Re: 656 S. San Vicente (CPC-2017-467-GPA-VZC-HD-SPR)
Council File Nos. 22-0922, 0922-S1, 0922-S2
Hearing Date: October 4, 2022 Item: 12, 13, 14

Re: 650-656 S. San Vicente Boulevard
CPC-2017-467-GPA-VZC-HD-SPR; VTT-74865
ENV-2017-468-EIR
Hearing Date: June 23, 2022

TO: Paul Caporaso, Los Angeles Department of City Planning – Major Projects

FIGURE
1

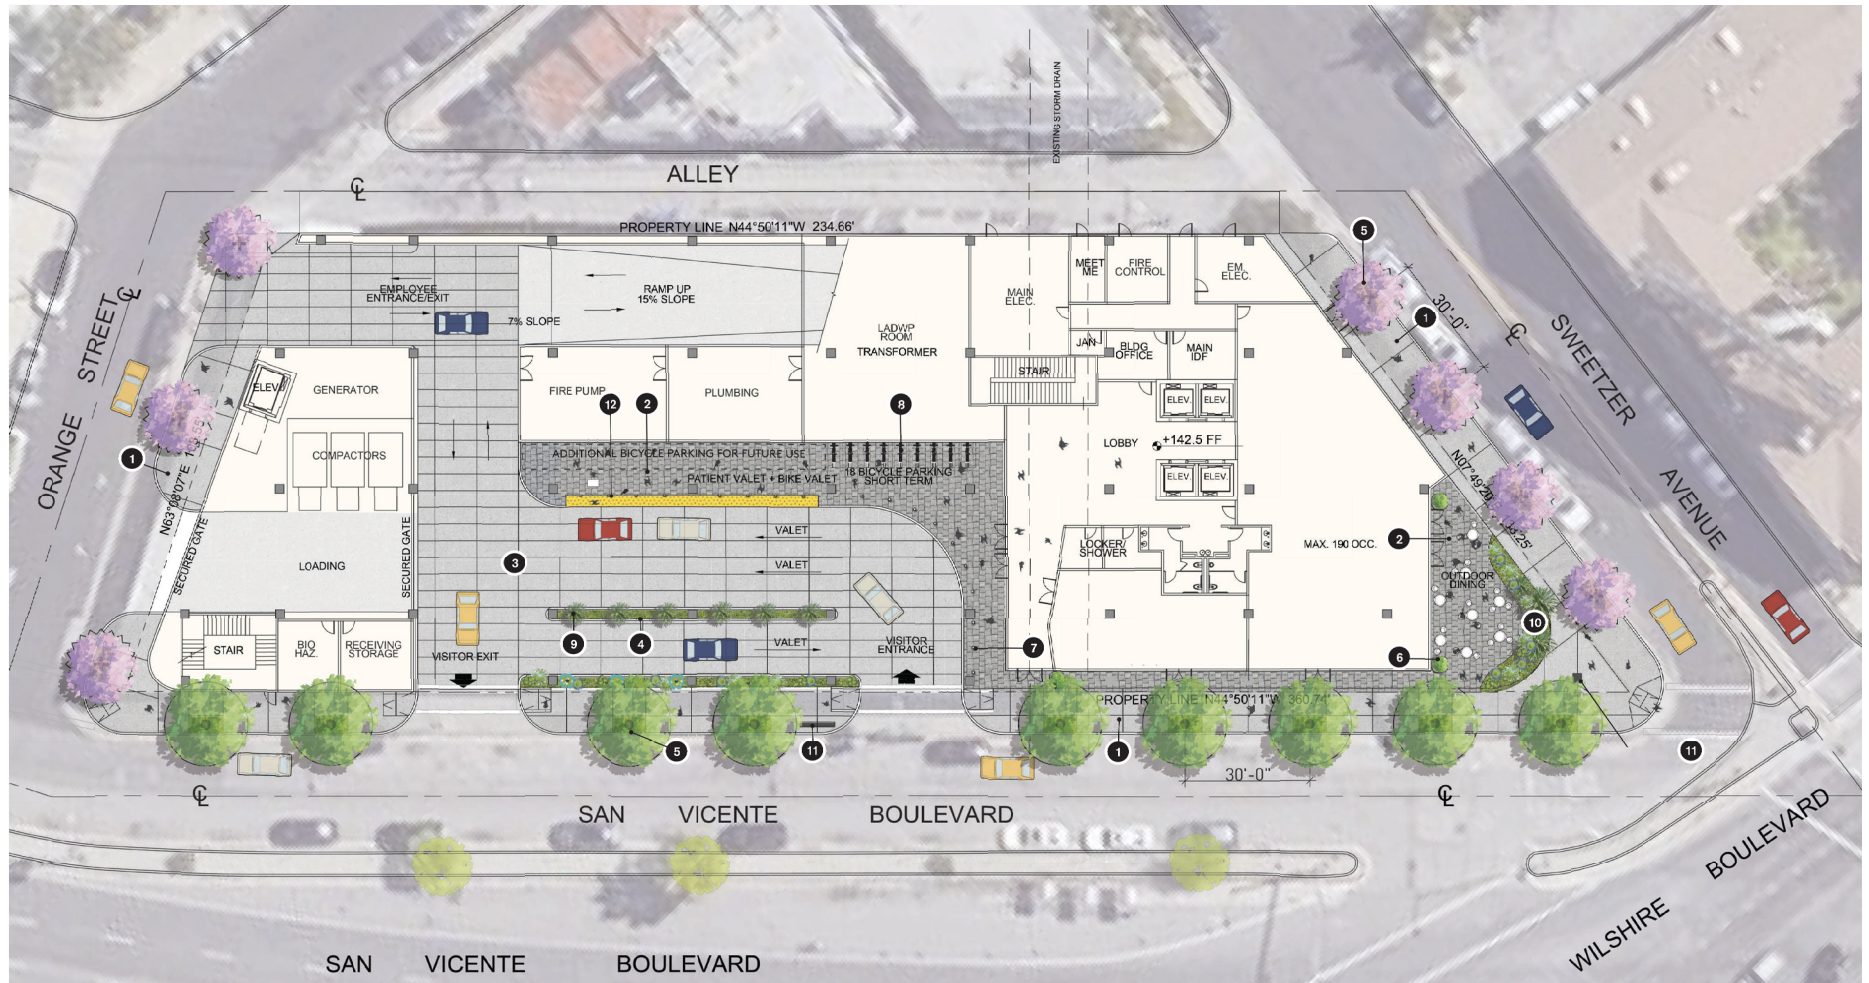
Page 4, Figure 1, Project Site Plan. A majority of the project traffic will be entering the frontage road of San Vicente Boulevard at the visitor entrance to the project. Although the project trip distribution assumed a 50/50 split between the visitor entrance/exit and the employee entrance/exit, in reality as much as 65% or more of the traffic entering the site may occur at the visitor entrance based upon the ULI (Urban Land Institute) data on Medical Office Parking demand. The project proposes to use a valet system for both visitors and employees to maximize the parking capacity of the site. There needs to be a queuing analysis to determine what will happen at the visitor/valet plus bike valet entrance to the site. This has not been quantified in the study and traffic could likely backup onto the San Vicente Boulevard frontage road and onto the adjacent streets such as Orange Street. A technical analysis of this needs to be provided to fully evaluate the ability for the valet system to work for both drop-off and pick-up conditions given the physical constraints of the site plan. Furthermore, no Valet Plan

As shown in the Site Plan, Figure II-3, page II-10 of Chapter II, Project Description, of the Draft EIR, the visitor entrance is located on the San Vicente Boulevard frontage road, with two entry queueing lanes, and the employee entrance is located on Orange Street with a queue lane to the second parking level. The Comment references the employee and visitor splits based on the peak parking demand ratios for the medical office use outlined in *Shared Parking, 3rd Edition* (International Council of Shopping Centers [ICSC], Urban Land Institute [ULI], and National Parking Association [NPA], February 2020) and not trip generation ratios during the commuter peak hours, which are based on the *Trip Generation Manual, 10th Edition* (Institute of Transportation Engineers [ITE], 2017). Figures 12 and 13 show the Project-related trips during the commuter morning and afternoon peak hours, which coincide with the times employees would travel to and from the Project site. Therefore, as shown, an equal distribution of employees and visitors entering and exiting the Project driveways was assumed. The number of trips generated by the Project was estimated using published rates from *Trip Generation Manual, 10th Edition* with application of allowable trip reductions per the City guidelines. The Project trip estimates, trip distribution, and trip assignment were established in coordination with and approved by the Los Angeles Department of Transportation (LADOT) through the Memorandum of Understanding (MOU) process. The Approved MOU is provided in Appendix A of the GTC Transportation Assessment.

LADOT's *Manual of Policies and Procedures* (Revised December 2020) identifies the standard reservoir length as 60 feet for 300 or more cars. The Project far surpasses this standard by having two entry lanes for visitors, each of which exceed this length, and a separate lane for employees at the second level that also far exceeds this requirement. *Manual of Policies and Procedures* also requires that a Parking Area and Driveway Plan be submitted to LADOT for approval prior to submittal of building permit plans for plan check by the City Department of Building & Safety (LADBS), to determine approval of the project's driveways and internal circulation or parking scheme. Therefore, the applicant will submit the Parking Area and Driveway Plan prior to issuance of the building permit.

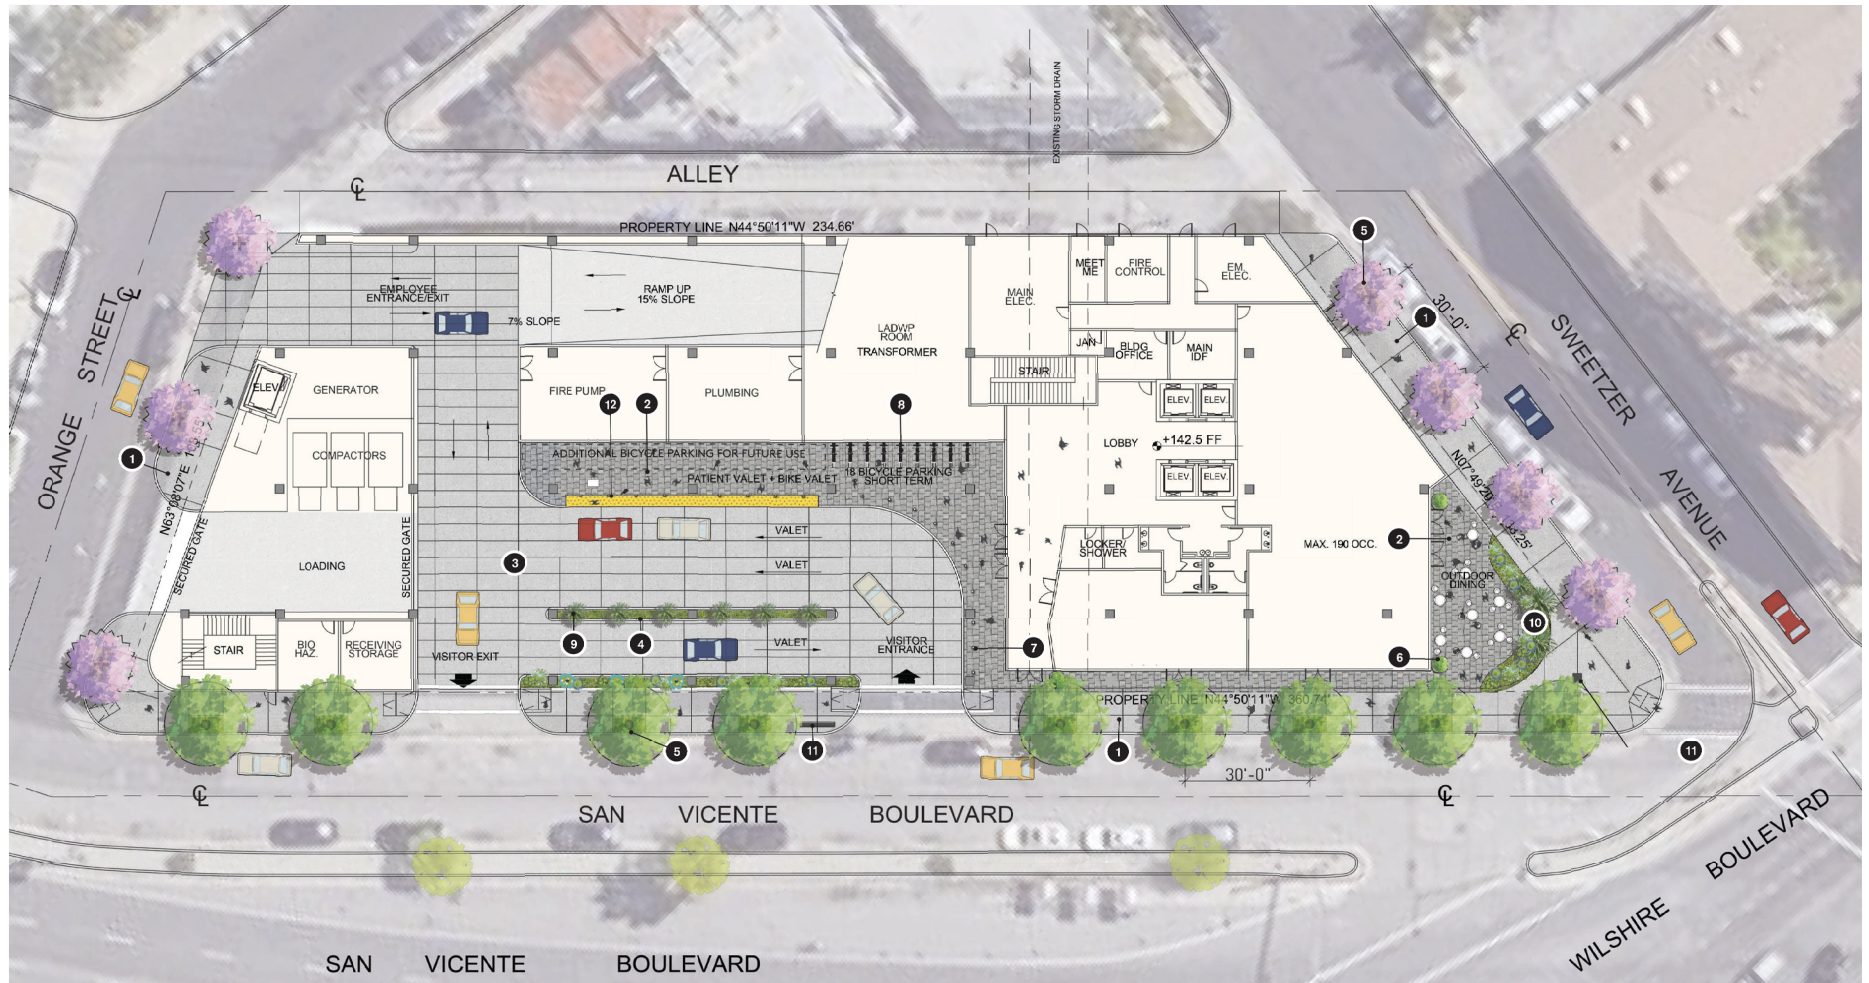
Page 4, Figure 1, Project Site Plan. A majority of the project traffic will be entering the frontage road of San Vicente Boulevard at the visitor entrance to the project. Although the project trip distribution assumed a 50/50 split between the visitor entrance/exit and the employee entrance/exit, in reality as much as 65% or more of the traffic entering the site may occur at the visitor entrance based upon the ULI (Urban Land Institute) data on Medical Office Parking demand. The project proposes to use a valet system for both visitors and employees to maximize the parking capacity of the site. There needs to be a queuing analysis to determine what will happen at the visitor/valet plus bike valet entrance to the site. This has not been quantified in the study and traffic could likely backup onto the San Vicente Boulevard frontage road and onto the adjacent streets such as Orange Street. A technical analysis of this needs to be provided to fully evaluate the ability for the valet system to work for both drop-off and pick-up conditions given the physical constraints of the site plan. Furthermore, no Valet Plan

As shown in the Site Plan, Figure II-3, page II-10 of Chapter II, Project Description, of the Draft EIR, the visitor entrance is located on the San Vicente Boulevard frontage road, with two entry queueing lanes, and the employee entrance is located on Orange Street with a queue lane to the second parking level. The Comment references the employee and visitor splits based on the peak parking demand ratios for the medical office use outlined in *Shared Parking, 3rd Edition* (International Council of Shopping Centers [ICSC], Urban Land Institute [ULI], and National Parking Association [NPA], February 2020) and not trip generation ratios during the commuter peak hours, which are based on the *Trip Generation Manual, 10th Edition* (Institute of Transportation Engineers [ITE], 2017). Figures 12 and 13 show the Project-related trips during the commuter morning and afternoon peak hours, which coincide with the times employees would travel to and from the Project site. Therefore, as shown, an equal distribution of employees and visitors entering and exiting the Project driveways was assumed. The number of trips generated by the Project was estimated using published rates from *Trip Generation Manual, 10th Edition* with application of allowable trip reductions per the City guidelines. The Project trip estimates, trip distribution, and trip assignment were established in coordination with and approved by the Los Angeles Department of Transportation (LADOT) through the Memorandum of Understanding (MOU) process. The Approved MOU is provided in Appendix A of the GTC Transportation Assessment.
